Rezoning Transportation Analysis
Petition Number: Insert Zoning Petition #2020-190
General Location Identifier: Tax ID 12522705

Revision Log:	Date	Description
	01-21-21	First Review (WB)

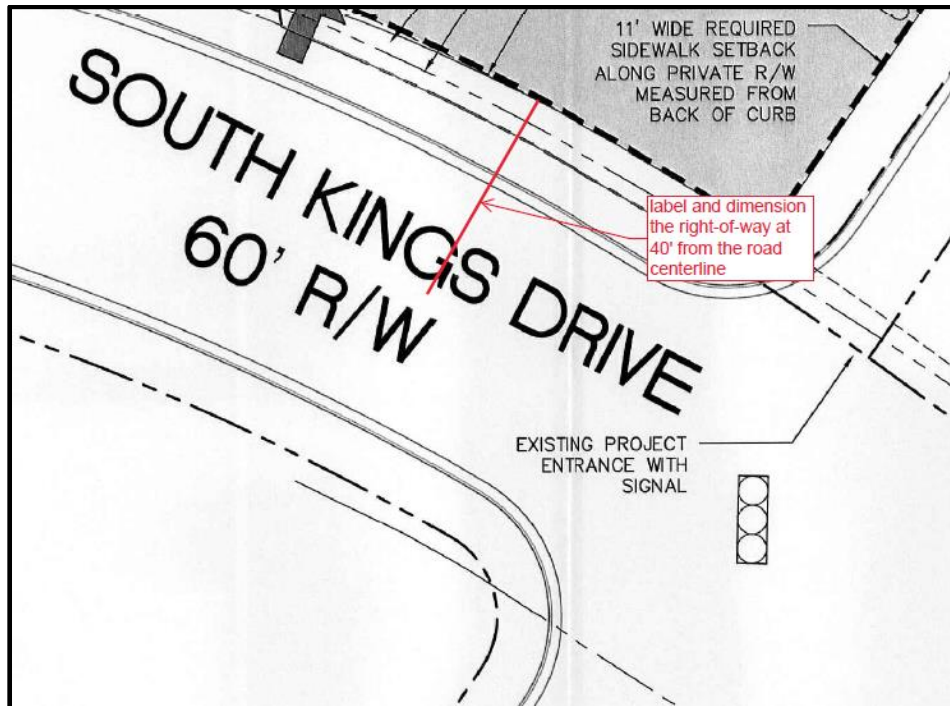
1. **Curbline:** The proposed zoning district has a setback measured from back of the existing or proposed future curbline.
 - a. **Kings Drive:** The future location of curb and gutter is in its existing location.

Label and dimension the curb and gutter from the centerline for each road on the site plan.

4.

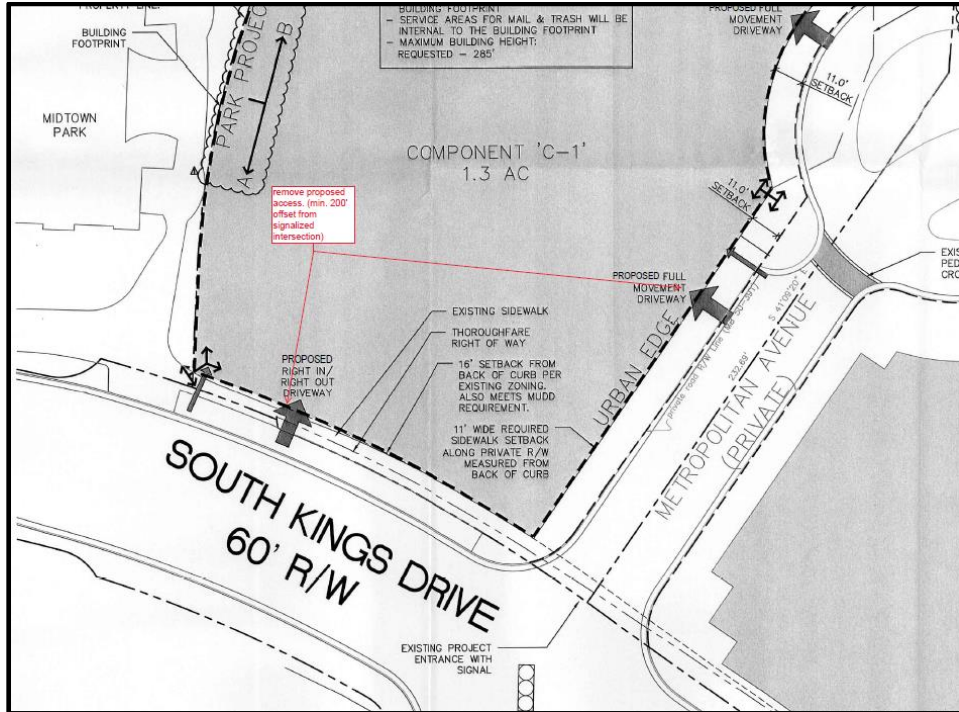
5. Revise site plan to remove proposed driveways shown within the 200' minimum required offset from a signalized intersection in accordance with the City of Charlotte Driveway Regulations (Chapter 4, page 19).
